**REQUEST**

Current Zoning: N1-A (neighborhood 1-A)  
Proposed Zoning: R-8(CD) (single family residential, conditional)

Approximately 4.86 acres located on the east side of Plott Road, south of The Plaza, and north of Meadowcroft Court.

The petition proposes to allow a residential development consisting of 32 single family attached homes in eight quadrplexes.

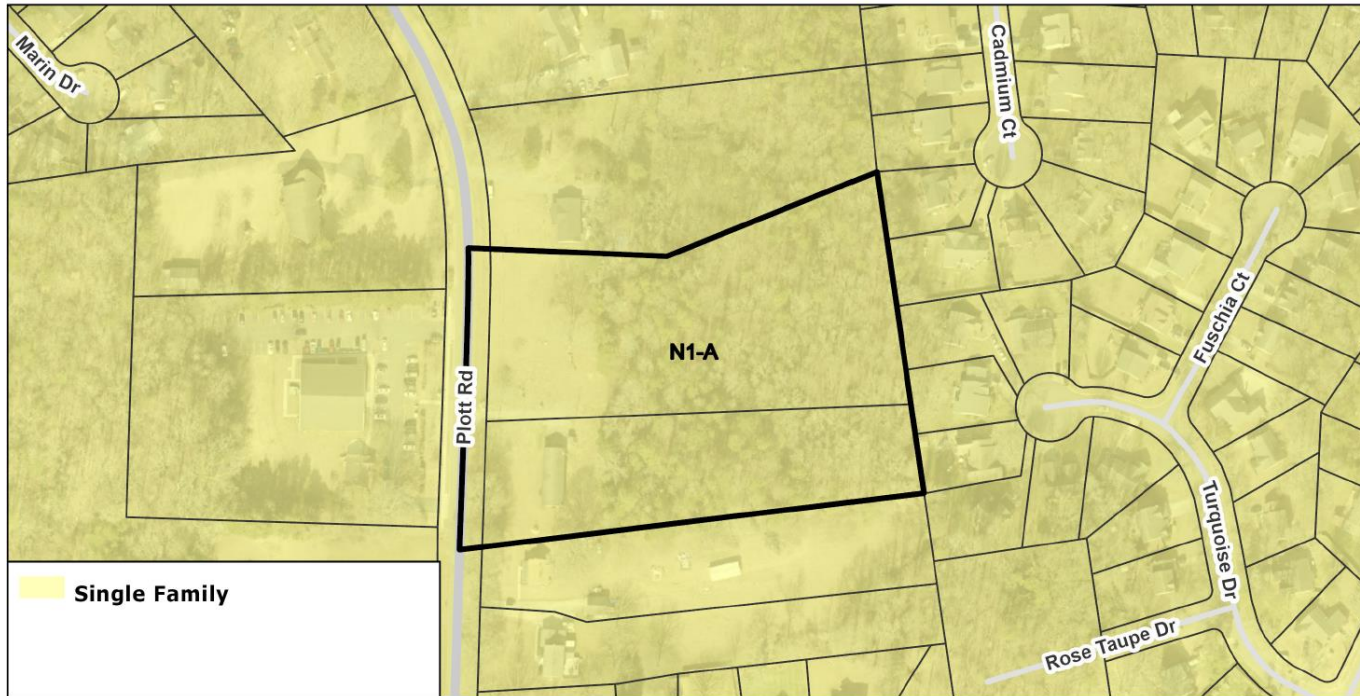
1. Development note needs to read as: For adjoining parcels receiving storm water discharge the petitioner shall analyze the adequacy of the existing storm water conveyance on the adjoining parcels to and including downstream parcels to the existing SDE. If the existing storm water conveyance is found to be inadequate, the Petitioner shall make a good faith effort with the property owner(s) to improve the storm water conveyance or mitigate the storm water discharge onto the adjoining parcels to the existing SDE.

2. Site would be required to provide a minimum of 15% tree save not 10%.
3. All applications for grading, building, demolition, land use, change of use or rezoning permits on all property, except single-family development shall require a tree survey. The survey shall identify all trees of eight-inch dbh or greater and all planted trees of two-inch caliper or greater and six feet in height that grow partially or wholly within the city right-of-way. ROW Trees should be protected.

4. Please clarify how the illustrated pocket park will be programmed.
5. There is no development note that commits to the illustration of a Class C buffer on the site plan.
